**GOVERNMENT OF THE DISTRICT OF COLUMBIA**  
**DEPARTMENT OF TRANSPORTATION**

**MEMORANDUM**

**SUBJECT:** BZA Case No. 17703A – Sidwell Friends School

Figure 1 Site Design and Access (Source: Applicant)

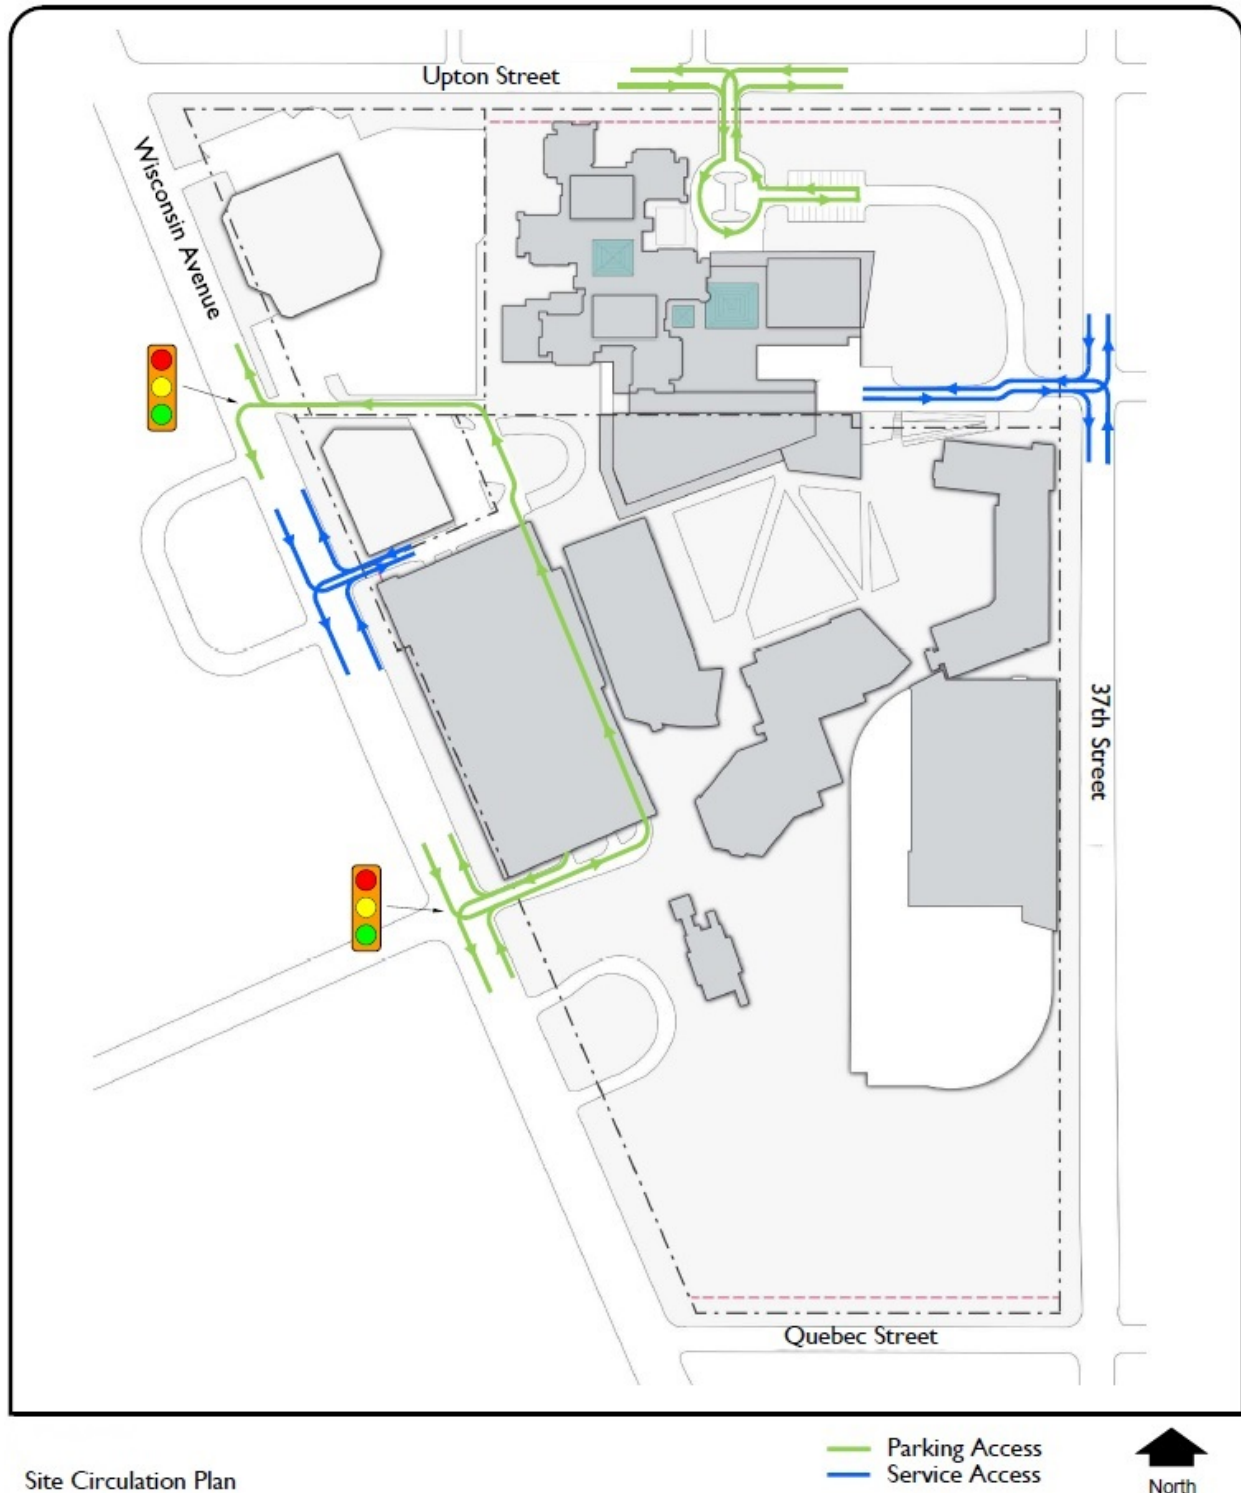
The existing street network has the potential to disperse site traffic surrounding the site in a way that minimizes the action's impact on the road network in the vicinity. These roads serve as vehicle, bicycle, and pedestrian access points for the site. However, some modifications to the street network are

needed to conform to DDOT's standards and provide optimal conditions. These changes are discussed in the Mitigations section of this report.

Figure 5 Site Pedestrian Circulation Plan (Source: Applicant)

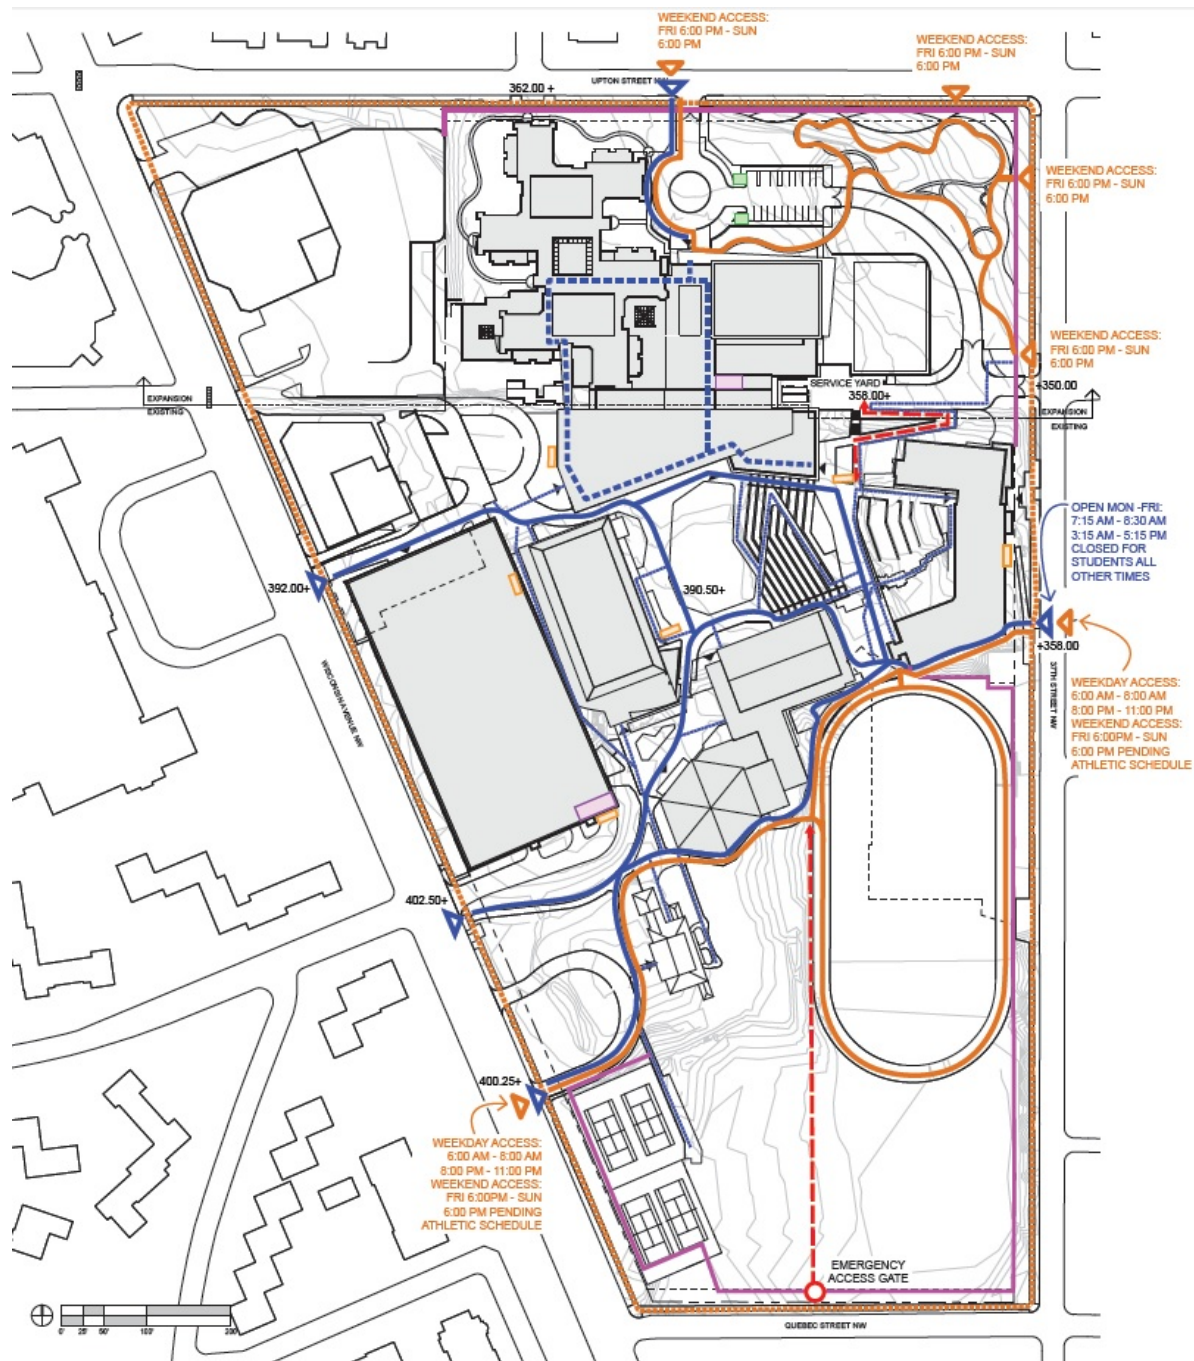
To address the existing deficiencies in the pedestrian network leading to the school, several infrastructure improvements are expected from the Applicant. Specifically, the following deficiencies must be addressed:

- Missing or substandard crosswalks on the eastern (Sidwell) and western (Rodman Street) leg of the Wisconsin Avenue/Rodman Street intersection;
- Missing detectable warnings on the eastern leg of the Wisconsin Avenue/Rodman Street intersection;
- Missing crosswalks, detectable warnings, and pedestrian signal heads on the eastern and western legs of the Wisconsin Avenue/Post Office/Sidwell intersection;
- Dedicated pedestrian path/sidewalk into the school property from the Wisconsin Avenue/Post Office/Sidwell intersection and the next service drive/entrance to the south;
- Missing sidewalk along 37<sup>th</sup> Street north of the school (from Upton Street past the alley, on the west side of the street).

While other missing sidewalk along the south side of Upton Street between 37<sup>th</sup> Street and Reno Road and along the north side of Tilden Street east of 37<sup>th</sup> Street could be installed by the school, DDOT has not deemed these as necessary to support this action.
